Access Compliance Report

Public Rights-of-Way

(Curb Ramps)

Intersection ID: 4891	Main Street: GRANARD_LN	Cross Street: PAINTED_PONY_CT	Location: NE
ADA ID: 87A087C41C4D	Ramp Type: Perp	Initial Pass/Fail: Fail	Overall Compliance: No
Severity Score: 12.5			
Codes/Mitigation Info/Possible Solution		Field Measurements/Component Compliance

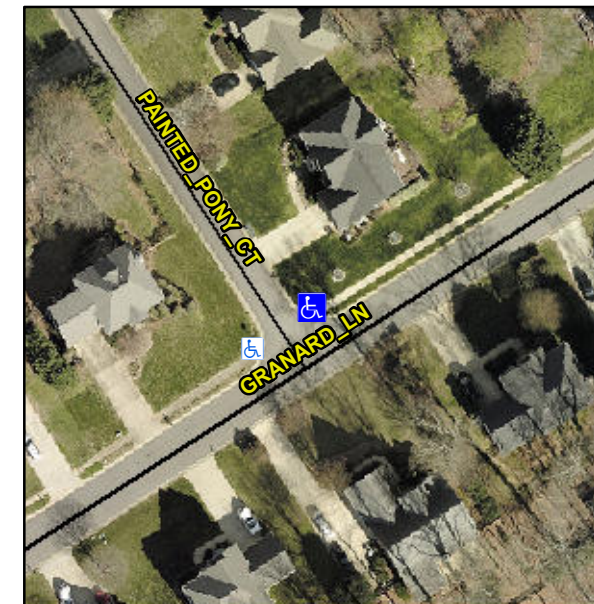
Not Found, R304.2.2

Compliance	Description	Data	Compliance	Description	Data
N/A	Ramp Length (in)	33.0	No	Ramp Slope (%)	8.6
Yes	Ramp Width (in)	48.0	Yes	Ramp XSlope (%)	0.9
N/A	Flare Type LT	N/A	N/A	Flare Type RT	N/A
N/A	Flare Slope LT (%)	N/A	N/A	Flare Slope RT (%)	N/A
N/A	Flare Traversable LT?	N/A	N/A	Flare Traversable RT?	N/A
N/A	Landing Length (in)	N/A	N/A	DWS Provided?	N/A
N/A	Landing Width (in)	N/A	N/A	DWS Contrast?	N/A
N/A	Landing Slope (%)	N/A	N/A	DWS Length (in)	N/A
N/A	Landing X Slope (%)	N/A	N/A	DWS Full Width?	N/A
N/A	Landing Curb? (Y/N)	N/A	N/A	DWS Offset (in)	N/A
N/A	Shared Landing?	N/A			
N/A	Gutter Ponding?	N/A	N/A	Gutter Slope (%)	N/A
N/A	Gutter Lip Ht (in)	N/A	N/A	Gutter X Slope (%)	N/A
N/A	Painted X Walk1?	No	N/A	Painted X Walk2?	N/A
	X Walk 1 Direction	To SW		X Walk 2 Direction	N/A
N/A	X Walk 1 Width (in)	N/A	N/A	X Walk 2 Width (in)	N/A
	X Walk 1 Slope (%)	0.5		X Walk 2 Slope (%)	N/A
	X Walk 1 X Slope (%)	1.9		X Walk 2 X Slope (%)	N/A

Remove & Replace Entire Ramp.
